ADDENDUM - 01

DATE: 22 October 2025

HVAC SYSTEMS REPLACEMENT-
LINDENWOLD HS
RYEBREAD Project # 5743Ga/Gb

1 OVERALL FIRST FLOOR PLAN - ME
ME101 SCALE 1/16" = 1'-0"

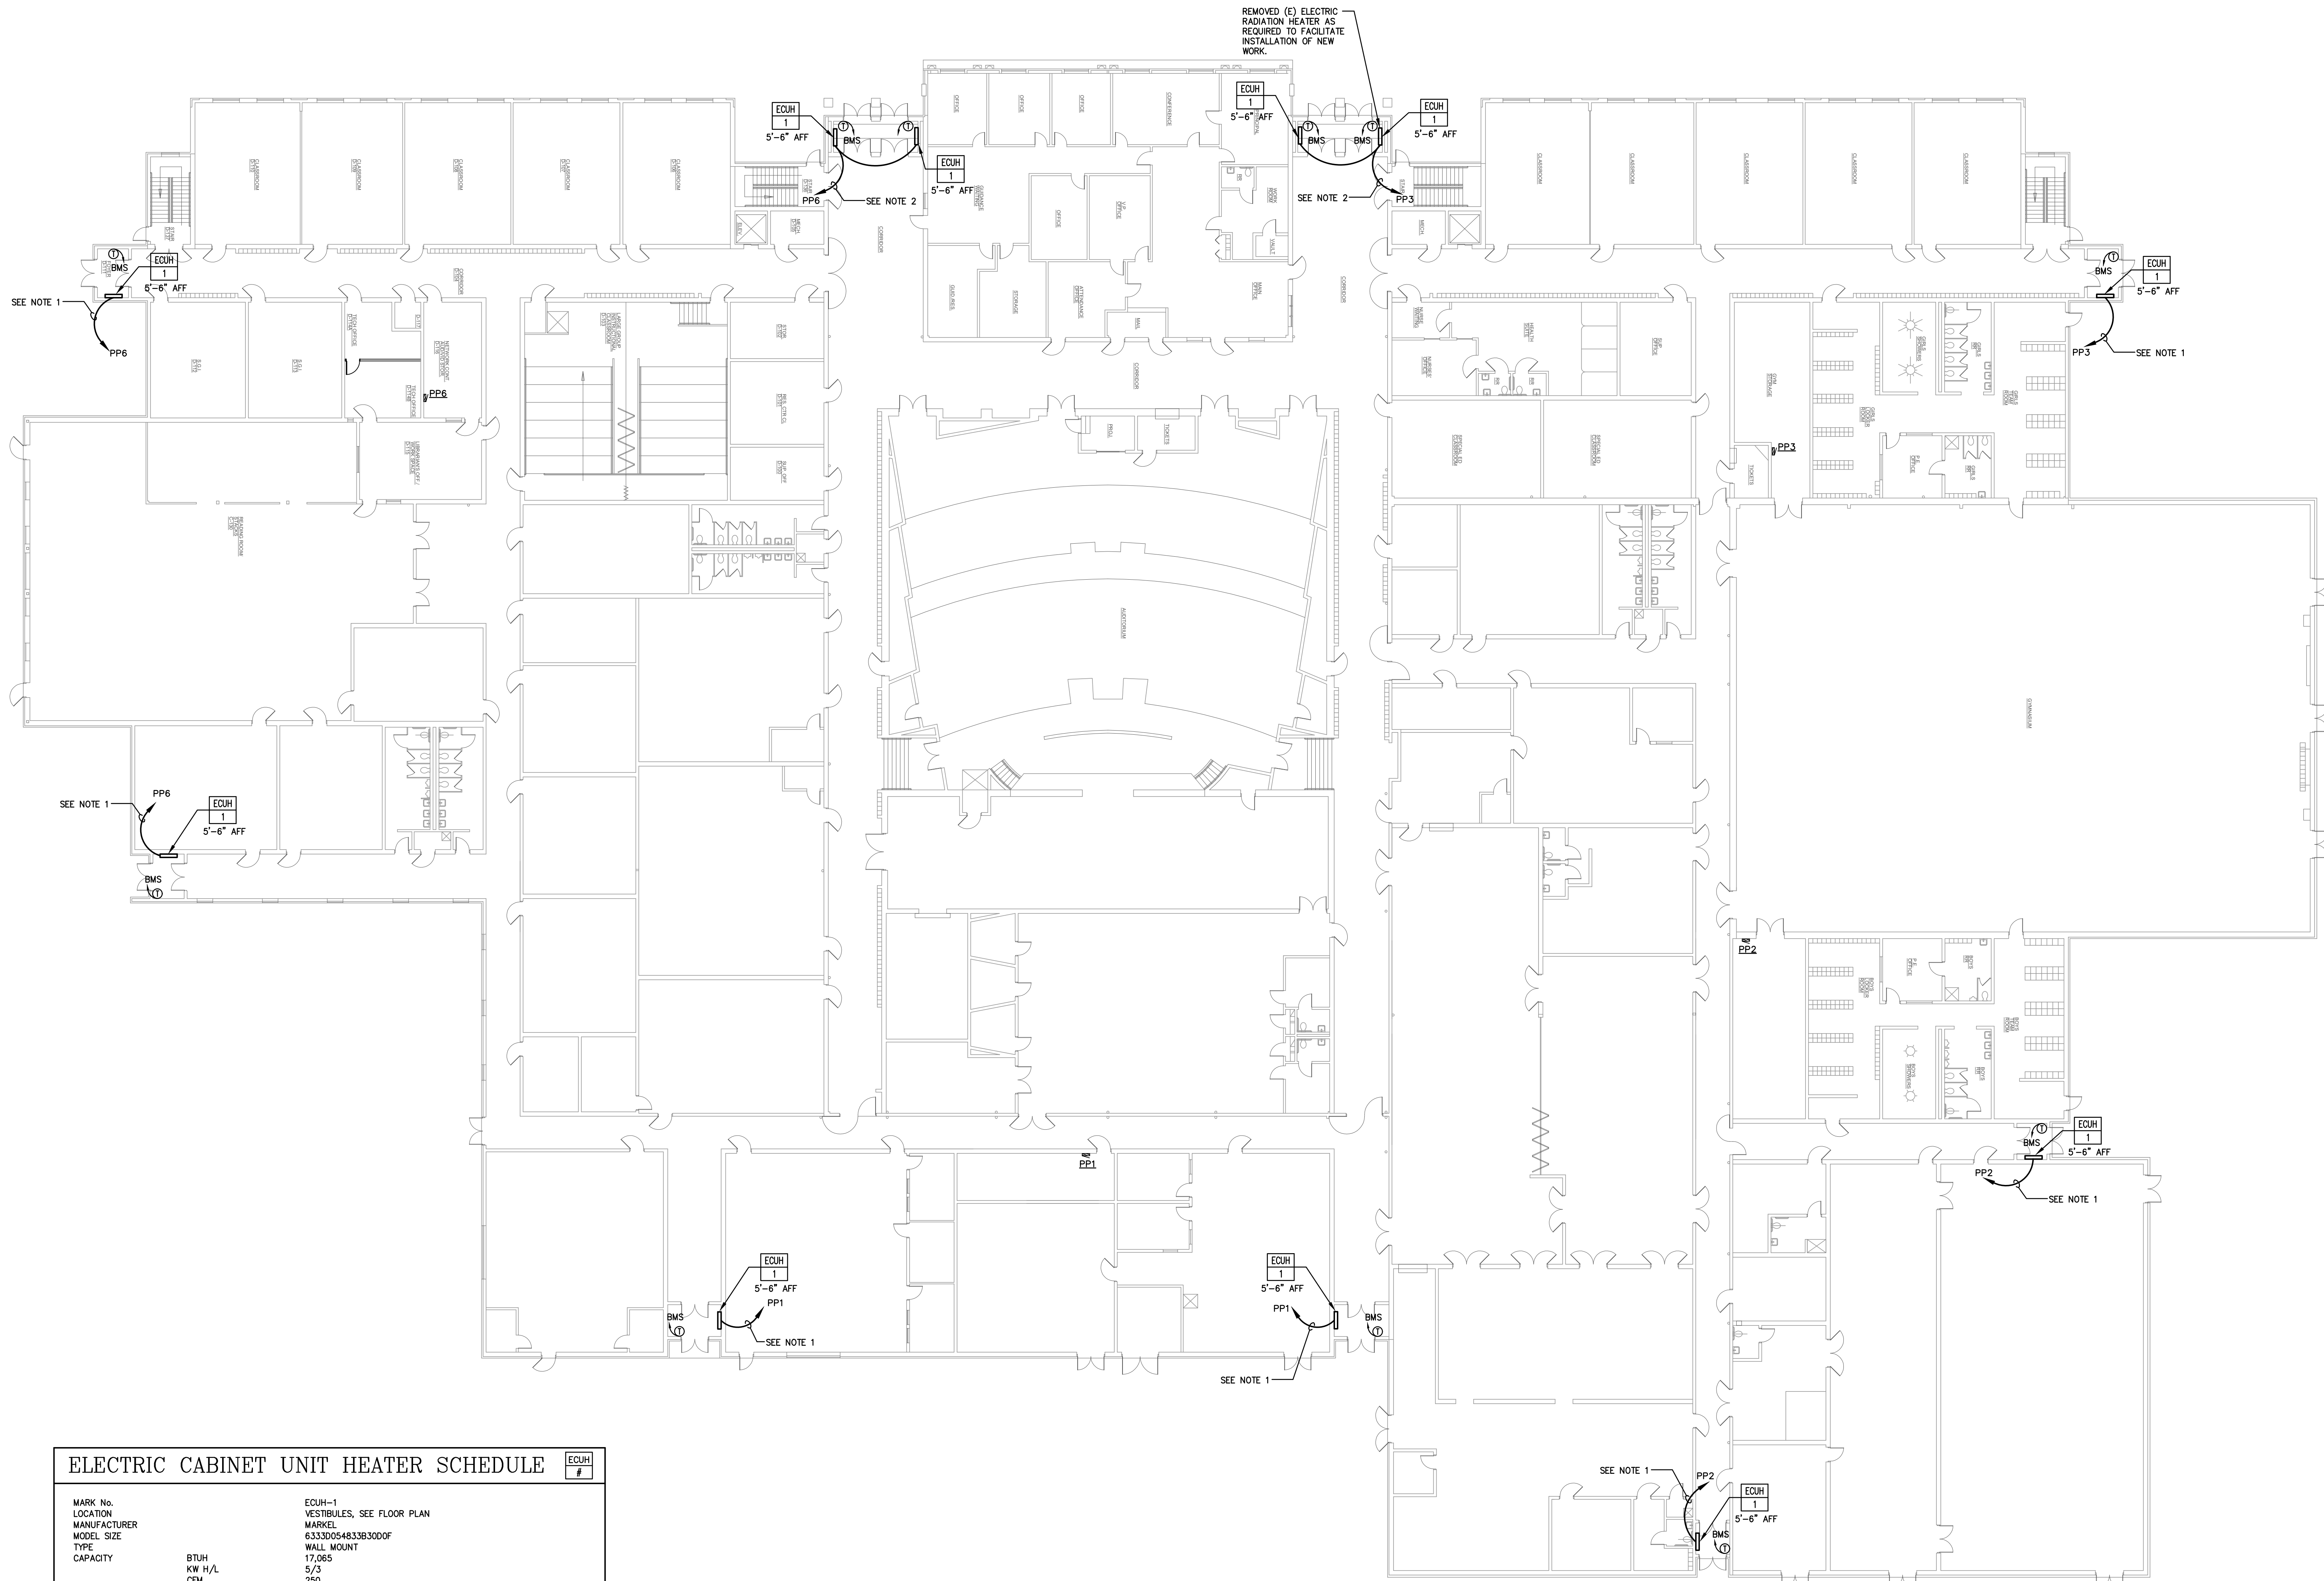
- 1.08 **ADDITION:** (Reference to Attached Drawing ME101): See attached drawing ME101, dated 22 October 2025. This drawing adds heat in the existing school vestibules. This work is to be part of the Base-Bid.

- NOTES:
- PROVIDE AND CONNECT TO 15A/3P CIRCUIT BREAKER IN EXISTING PANEL VIA 3 #12 & 1 #12 GRD - 3/4". BREAKER TO MATCH EXISTING PANEL FOR TYPE AND AIC RATING.
 - PROVIDE AND CONNECT TO 20A/3P CIRCUIT BREAKER IN EXISTING PANEL VIA 3 #12 & 1 #12 GRD - 3/4". BREAKER TO MATCH EXISTING PANEL FOR TYPE AND AIC RATING.
